CITY OF HUBER HEIGHTS STATE OF OHIO

City Council Work Session

Case BDP 23-17 - BP-OTP, LLC - Rezoning/Basic Development Plan - 4949 Chambersburg Road

To: Huber Heights City Planning Commission

LIGHTING PLAN

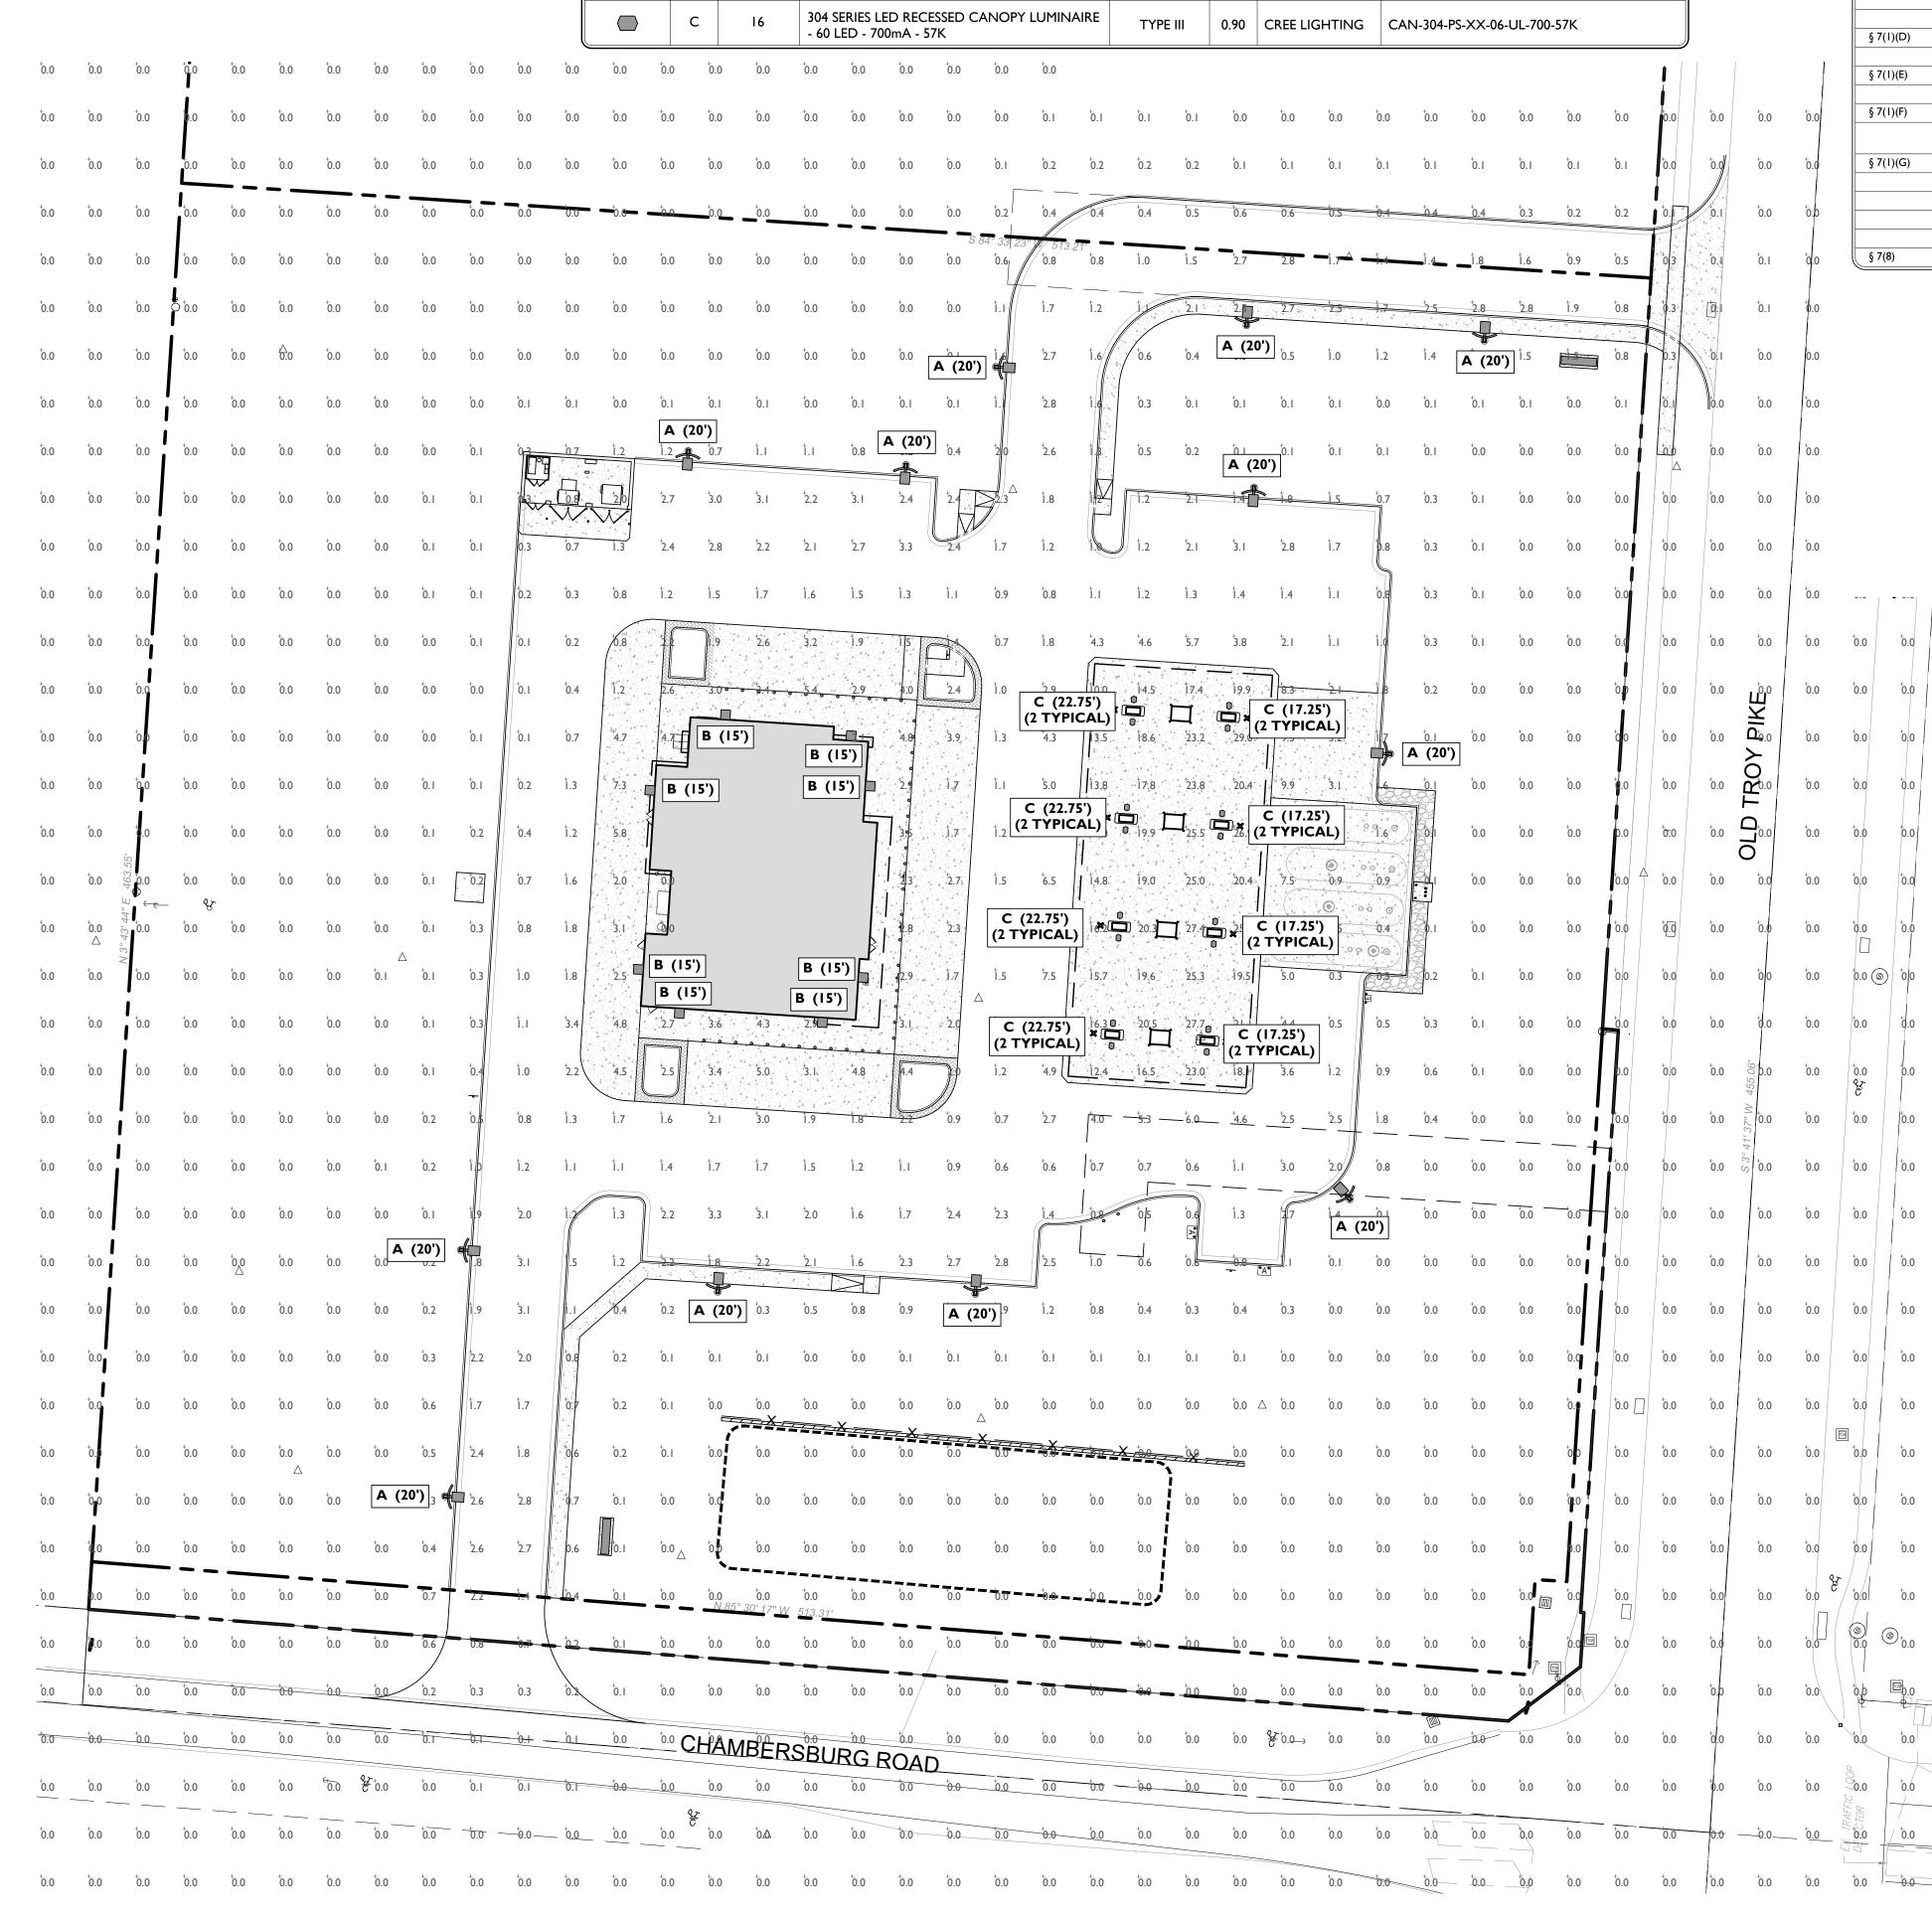
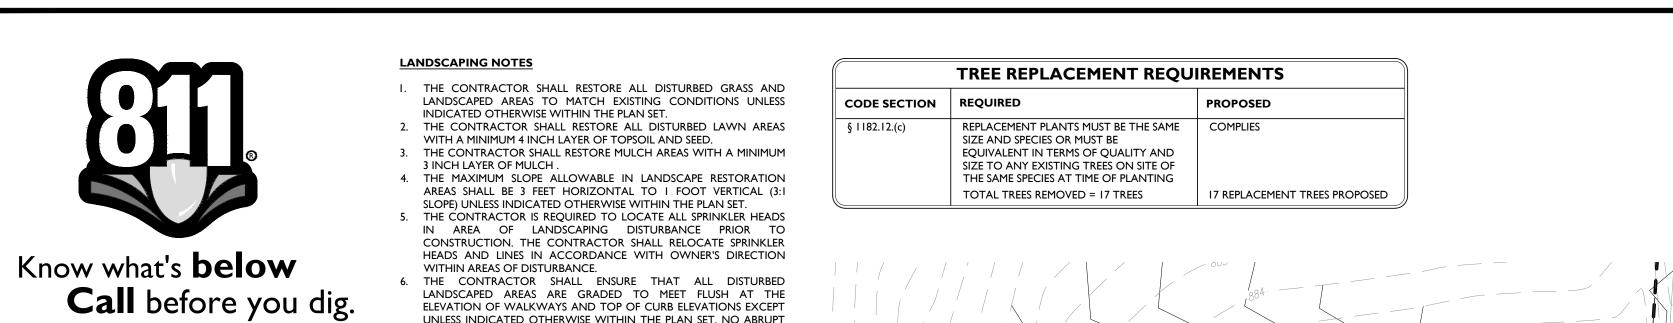
- The lighting plan submitted with the application meets all requirements. The proposed fixture height is 20 feet, and the fixture types meet the code. The photometric analysis indicates no light trespasses across the property lines.

LANDSCAPING PLAN

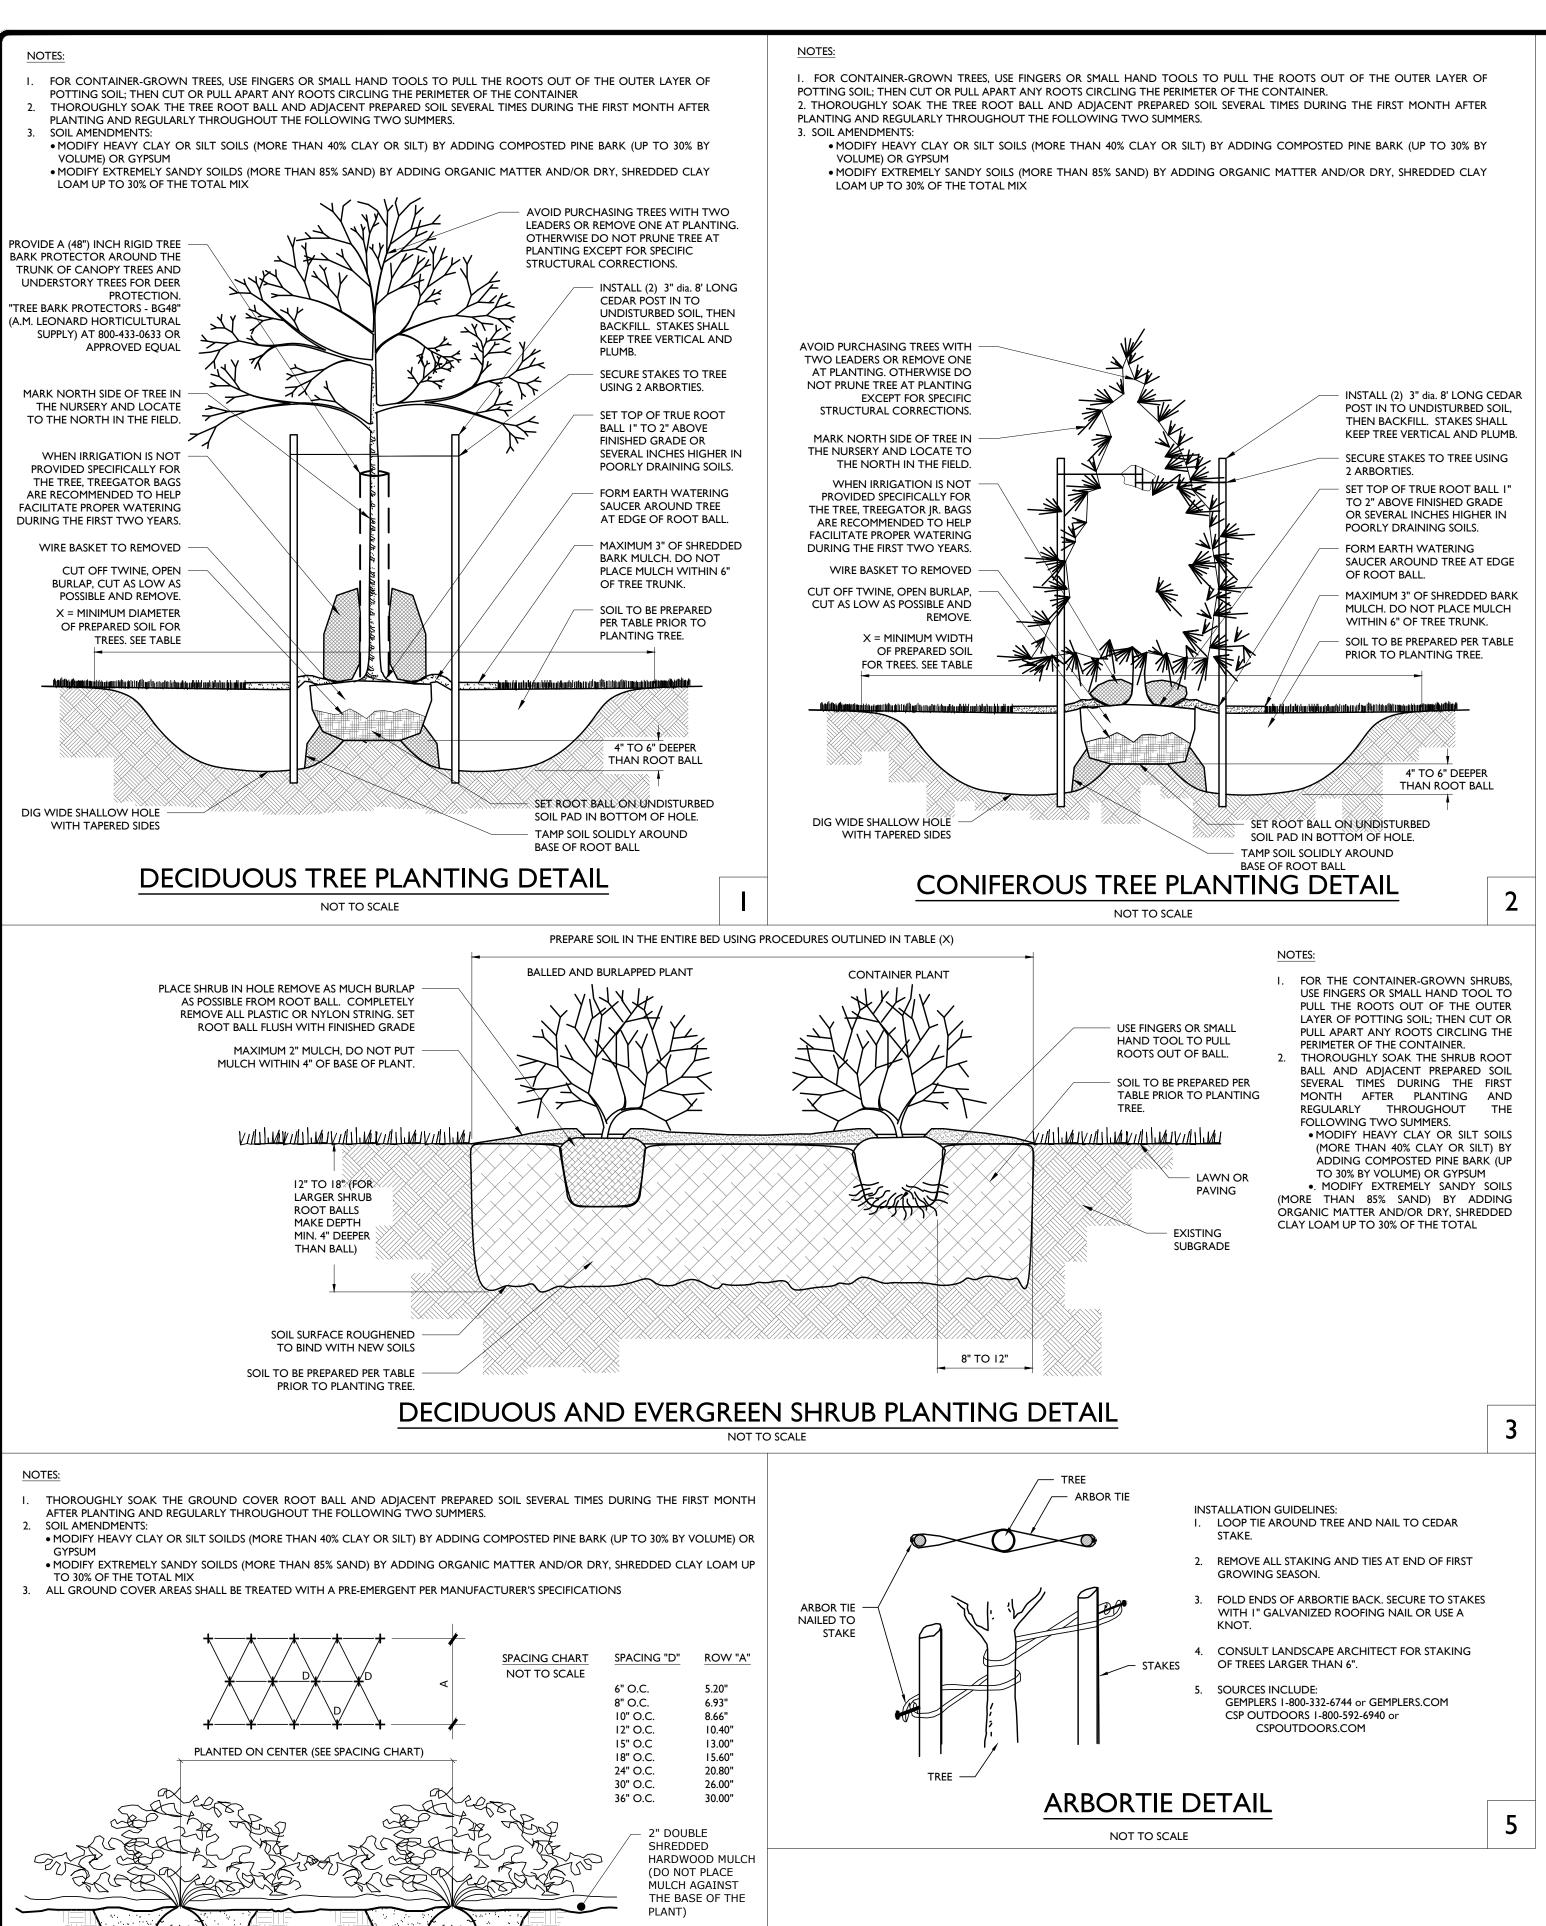
- The site plan meets all parking and building setback and yard requirements.
- Nineteen street trees are required. The preliminary landscaping plan shows 19 street trees. However, due to grading issues and Chambersburg Road's planned widening, most of them are not near the sidewalk. During the Detailed Development plan review, staff will work with the applicant to place the required trees appropriately.

• The plans appear to meet the landscaping requirements but will be verified when the detailed development plan is submitted.

- The applicant shall assess the health of the existing trees along the site's
 perimeter that will be incorporated into the landscaping plan. Healthy trees shall
 be identified and incorporated into the landscaping plan as appropriate, subject
 to approval as part of the Detailed Development Plan. The applicant shall also
 develop a plan to protect key trees during construction, subject to staff approval.

- The applicant shall work with staff to determine the final street tree placement during the Detailed Development Plan phase.
- Signs shall conform with Chapter 1189, unless otherwise approved in the Detailed Development Plan by the Planning Commission.
